World Forum for Harmonization of Vehicle Regulations

187th session

Proposal for Supplement 3 to the 07 series of amendments to UN Regulation No. 48 (Installation of lighting and light-signalling devices)

Submitted by the Working Party on Lighting and Light-Signalling*

Annex 1, item 9.22., amend to read:

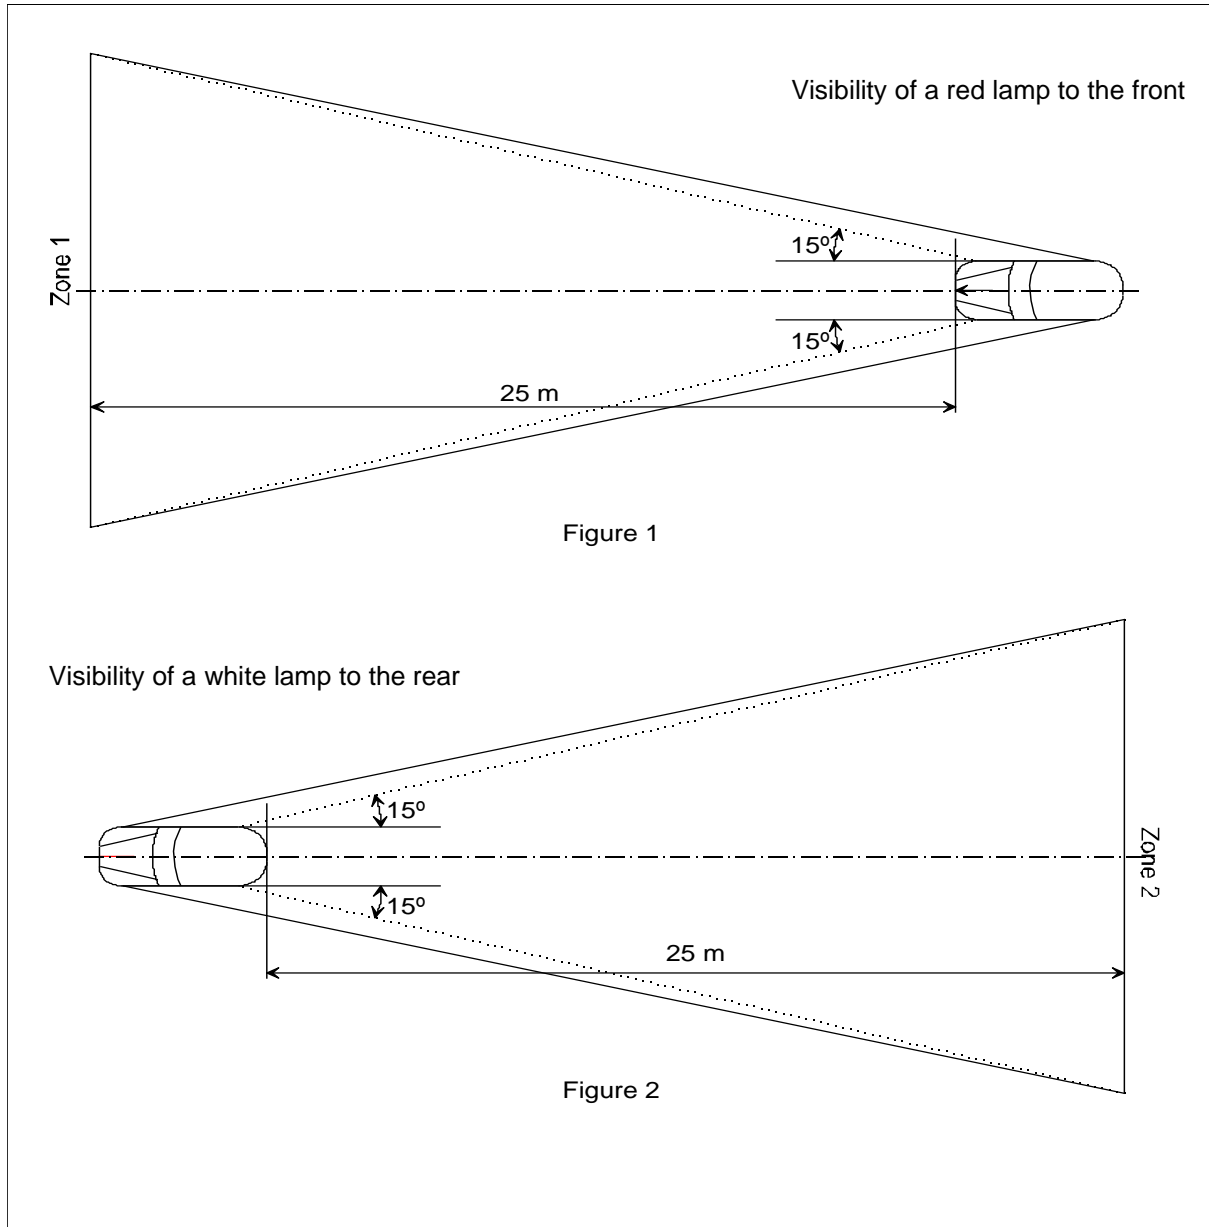
"9.22.	Adaptive front lighting system (AFS):	yes/no ²
9.22.1.	Main-beam ADB	yes/no ²
9.22.1.1.	Main-beam ADB + Driver Assistance Projection	yes/no ² "

“Annex 4

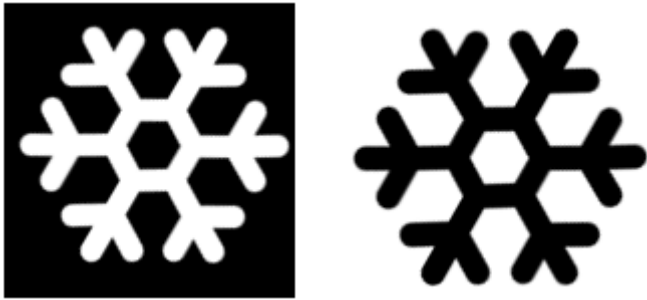
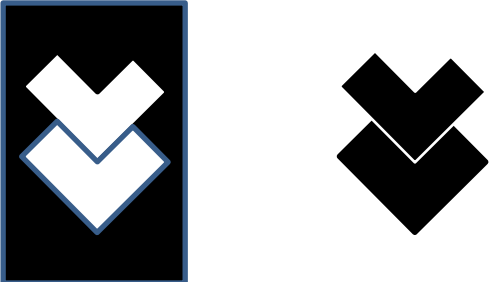
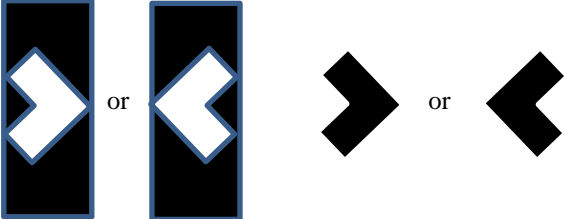
In their respective planes, the zones 1 and 2 explored by the eye of the observer are bounded:

- In height, by two horizontal planes 1 m and 2.2 m respectively above the ground;
- In width, by two vertical planes which, forming to the front and to the rear respectively an angle of 15° outwards from the vehicle's median longitudinal plane, pass through the point or points of contact of vertical planes parallel to the vehicle's median longitudinal plane delimiting the vehicle's overall width; if there are several points of contact, the foremost shall correspond to the forward plane and the rearmost to the rearward plane.”
